**CITY OF MCMINNVILLE
PLANNING DEPARTMENT**
231 NE FIFTH STREET
MCMINNVILLE, OR 97128

DECISION, CONDITIONS, FINDINGS OF FACT AND CONCLUSIONARY FINDINGS OF THE MCMINNVILLE HISTORIC LANDMARKS COMMITTEE FOR THE APPROVAL OF A NEW BUILDING AT 631 NE 1ST STREET WITHIN THE DOWNTOWN DESIGN AREA

- DOCKET:** DDR 1-21 (Downtown Design Review for New Construction)
- REQUEST:** Approval of a Downtown Design Review application to allow for the construction of a new building at 631 NE 1st Street on a parcel that is currently vacant. The proposed work includes construction of the new building, parking areas, and drive aisles. The proposal includes a request for an exception to the typical front setback requirement to allow for a plaza/courtyard area in front of the building.

The plaza space and setback can be identified in the site plan below:

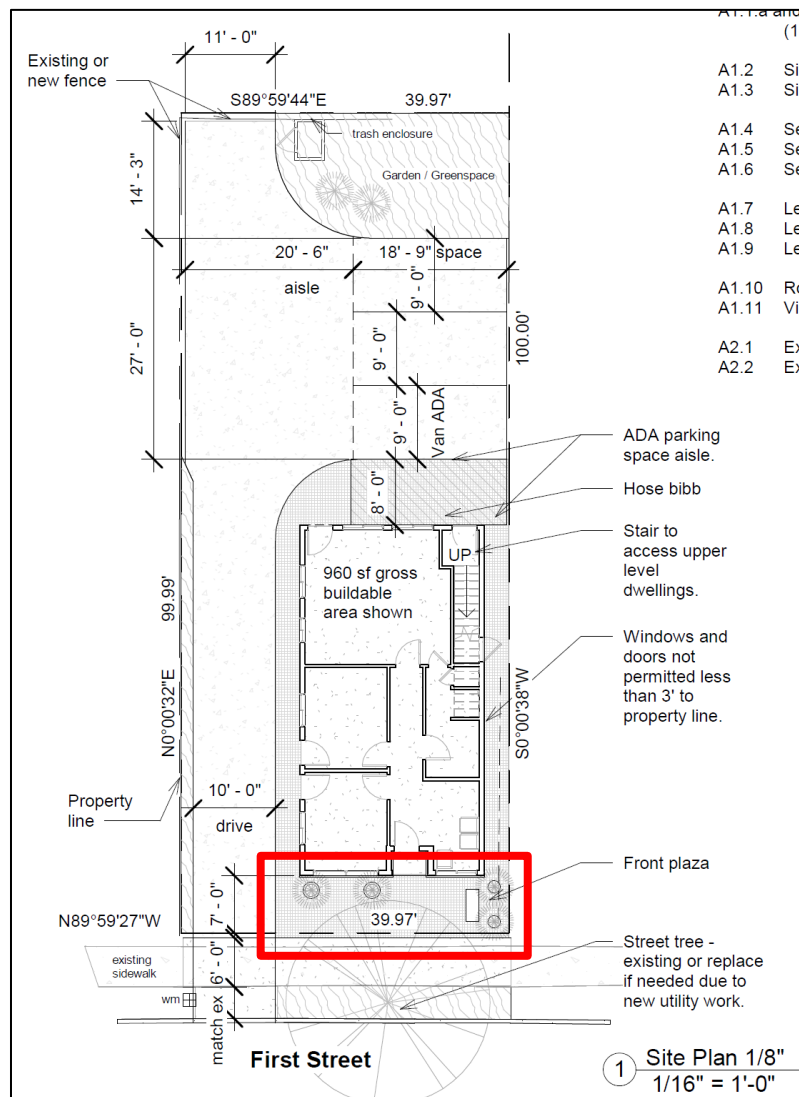
FINDING: SATISFIED WITH CONDITION #2. The City concurs with the applicant’s findings, and allows for the exception to the zero foot setback from the property line based on the fact that the plaza space is being provided. The plaza space, and therefore the 7 foot setback, is allowed based on the reasoning provided by the applicant. The City adds that the applicant also provided visual examples of other plaza spaces that allowed for building setbacks within the Downtown Design Area. These examples of other plaza spaces are available within the application materials attached to this decision document (and on file with the Planning Department). In order to clearly identify this space as a plaza, a condition of approval is included to require that the plaza space be of a different material or finish (concrete scoring, etc.) to provide visual identification of the plaza space and differentiation between the plaza and the adjacent sidewalk and drive aisle spaces.

2. That the plaza space be of a different material or finish (concrete scoring, etc.) to provide visual identification of the plaza space and differentiation between the plaza and the adjacent sidewalk and drive aisle spaces.

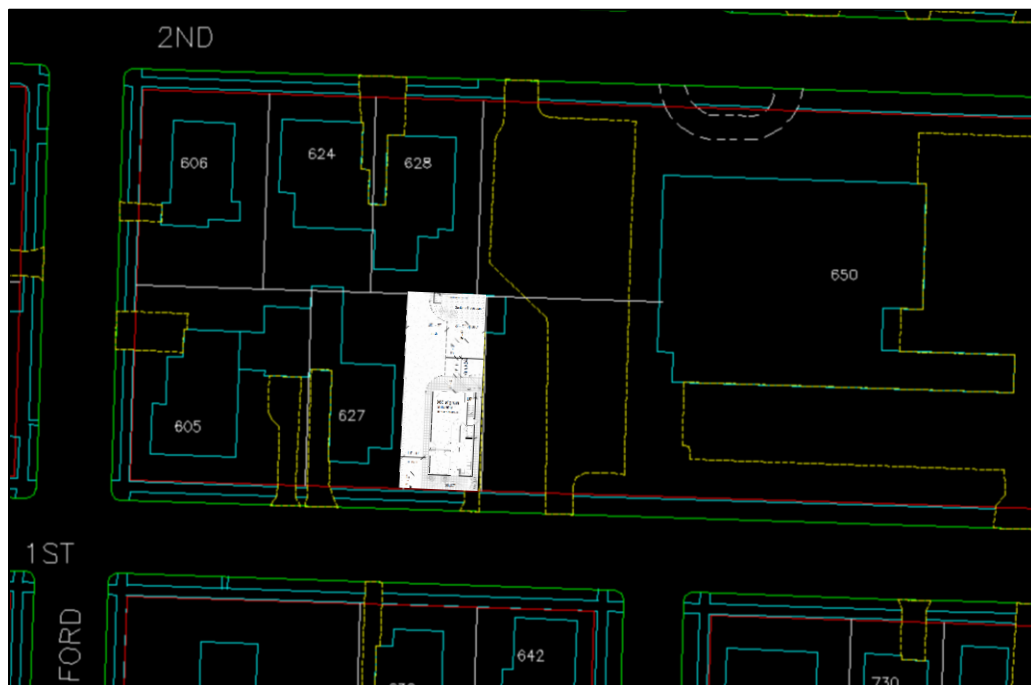
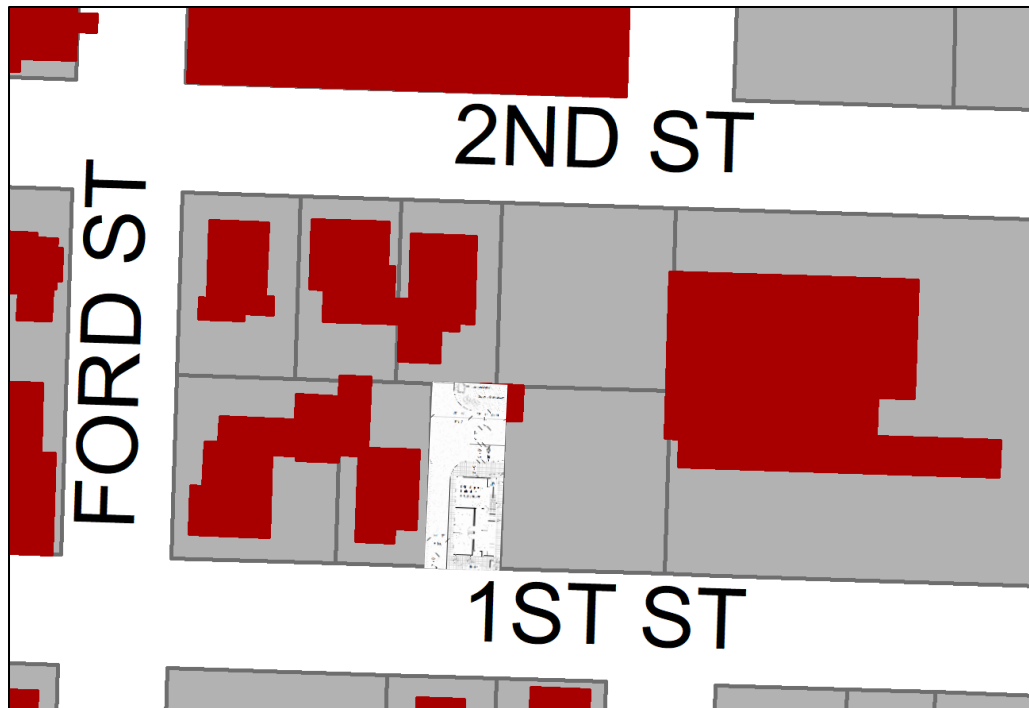
FINDING: SATISFIED. The City partially concurs with the applicant’s findings. The City concurs that the rectangular footprint and size of the footprint of the proposed building are similar in configuration to adjacent and nearby historic buildings on the same block. The City adds that the combination of the proposed building footprint size and location of the building on the lot will result in a similar configuration to the lots on which the adjacent historic buildings are located. The proposed configuration of the new building includes a slight setback that is not quite as large but is similar to adjacent historic buildings on the same block. The configuration of the proposed building on the lot also provides for other open spaces on the site that are similar to adjacent properties. These open spaces will allow for a plaza in the front of the building (usable front yard space), a driveway/drive aisle along the side of the building, parking areas behind the building, and a small usable green space behind the building similar to back yards of adjacent properties. This configuration and location of the building on the lot results in a similar proportion of the lot being covered with building footprint as exists on the lots of adjacent historic buildings.

In regards to massing, the City partially concurs with the applicant's findings. The City does acknowledge that the proposed design of the building, which meets the applicable Downtown Design Standards as described in the findings above and below, will result in a building that appears visually different from adjacent historic buildings on the same block. This is because, in this case, the existing historic buildings on the same block are residential buildings and uses. While different in visual appearance, the City finds that the overall massing of the proposed new building is similar to adjacent and nearby historic buildings on the same block. Besides the single story building immediately adjacent to the west, all other historic buildings on the same block are 2-2.5 stories, have square or rectangular building forms, and are of a height that is similar to the proposed new building when incorporating the maximum height of the peak of the gable or hipped roofs. The height of the proposed new building is approximately 34 feet. The

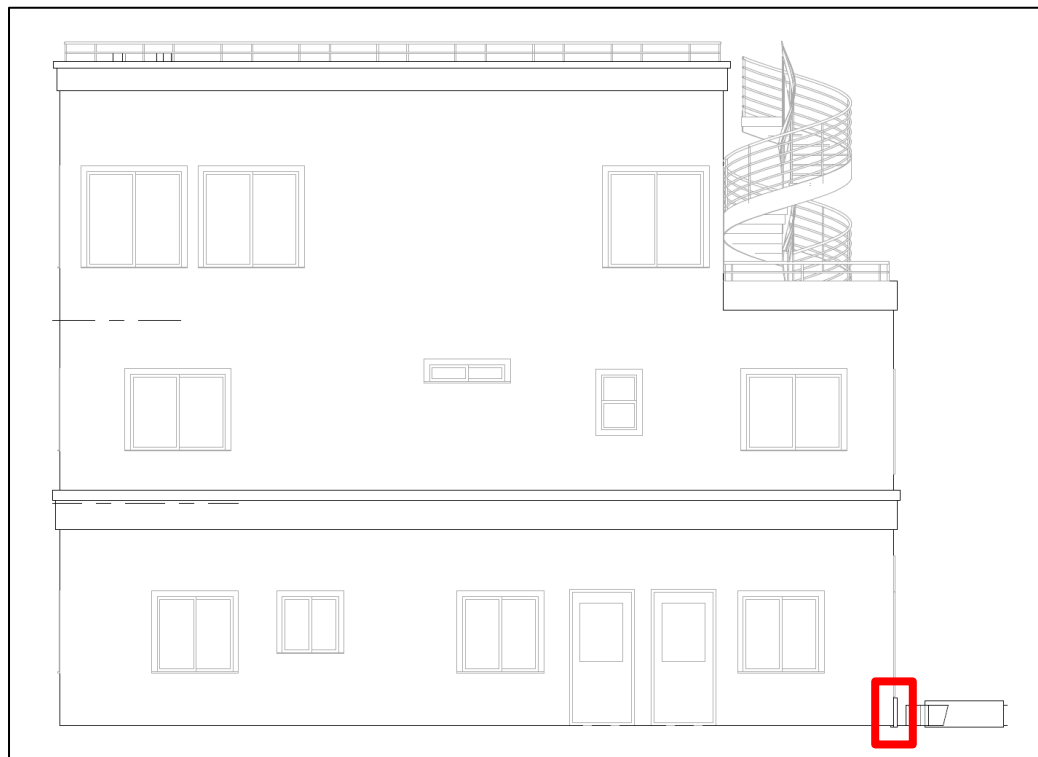
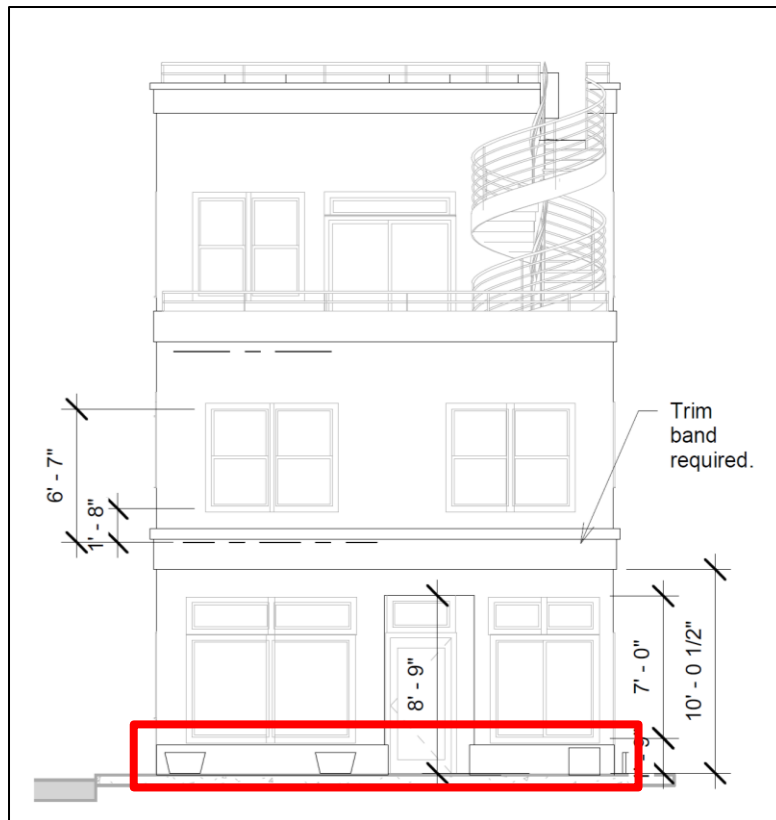
FINDING: SATISFIED. The City concurs with the applicant’s findings. The bulkhead feature as identified in the front elevation has a dimensionality that extends outward from the remainder of the building wall. The stucco bulkhead proposed can be seen below:

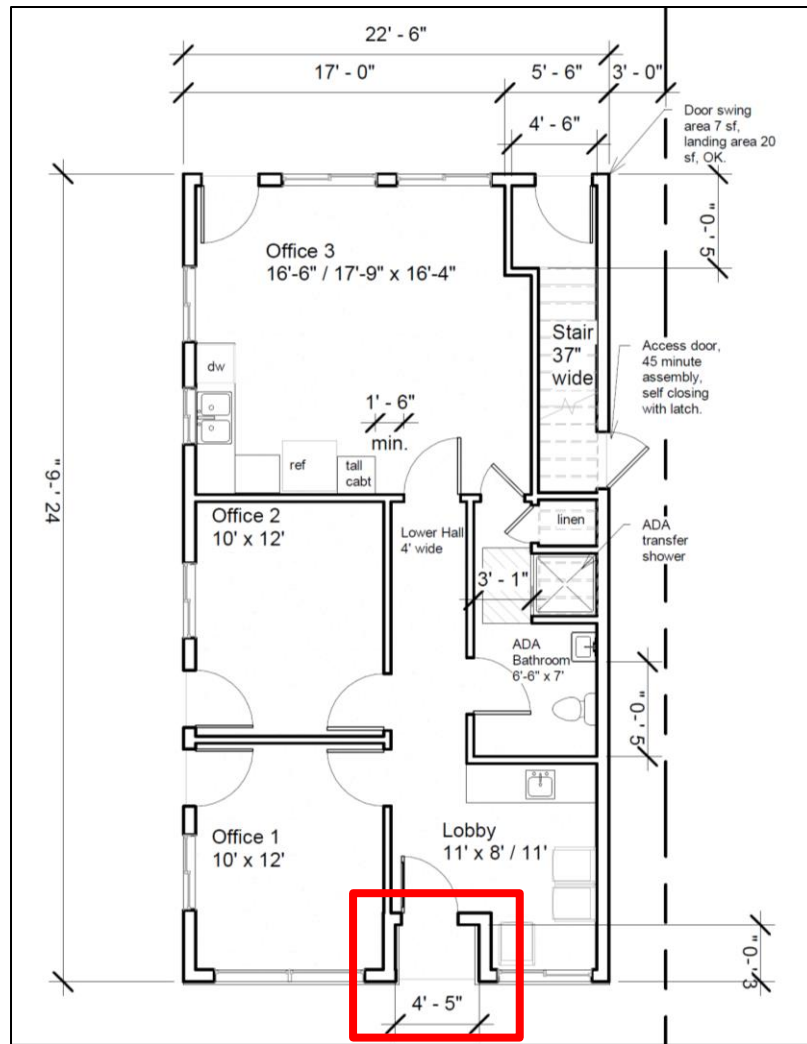
FINDING: SATISFIED. The City concurs with the applicant’s findings, but adds that the glazing below the transom line (which is 8’ 9” from grade) is approximately 137.83 square feet. Based on the façade width of 22.5’, the area below the transom line is approximately 196.875 square feet. Therefore, the amount of glazing below the transom line is just over 70%, and the amount of glazing below the horizontal belt course between the first and second stories (which is at just about 10’ in height) is approximately 61%.

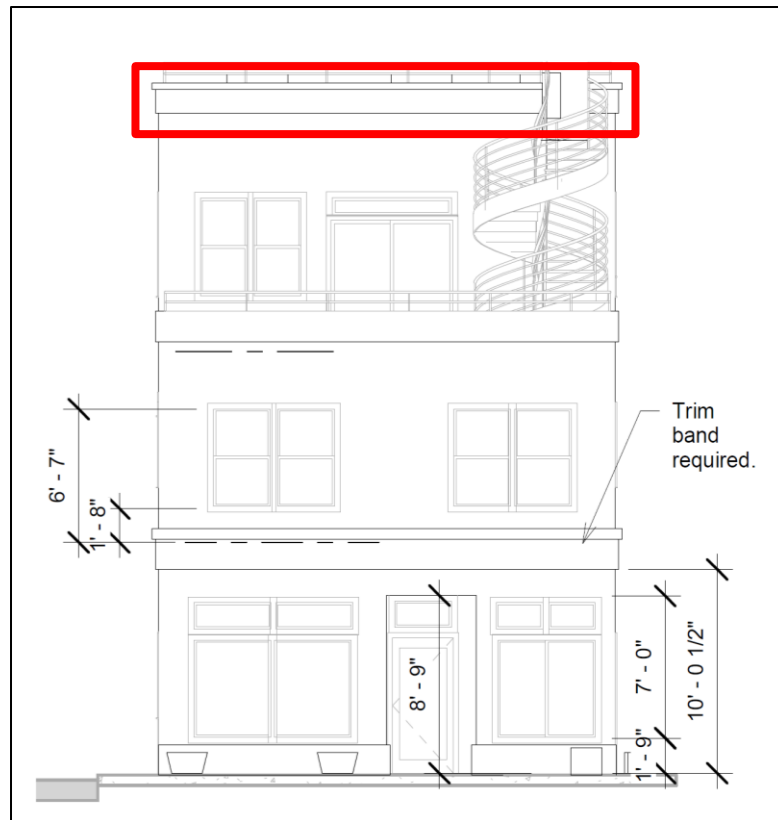
FINDING: SATISFIED. The City concurs with the applicant’s findings. The City would add that the decorative cornice or cap at the roofline is proposed to continue around the entirety of the building on all four elevations. The decorative cornice feature as identified in the elevations includes a narrow band along the top of the cornice and a wider band along the lower portion of the cornice. Each layer of these two bands have different dimensions that extend outward from the remainder of the building wall. The cornice/cap trim can be seen below:

The floor plans and window locations shown in the floor plans can be seen below (note that the same applies to the third story, but only the first and second story are identified below). Areas where windows do not appear to be completely flush to the inside face of the building wall are identified.

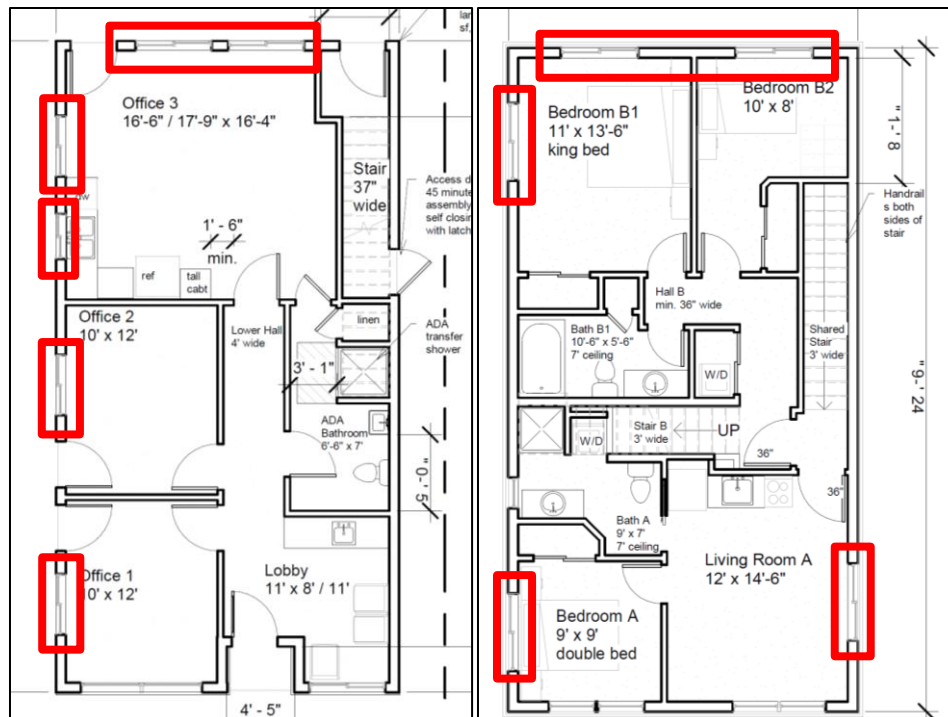
FINDING: SATISFIED WITH CONDITION #3. The City concurs with the applicant’s findings, but adds that the windows on the side elevations appear in the floor plans to be flush to the outside face of the building. A condition of approval is included to require that on the building permit construction plans submitted for the proposed building, all windows on the building shall be set flush to the inside face of the building so that they are recessed and not flush against the surface of the outer wall.

3. That on the building permit construction plans submitted for the proposed building, all windows on the building shall be set flush to the inside face of the building so that they are recessed and not flush against the surface of the outer wall.
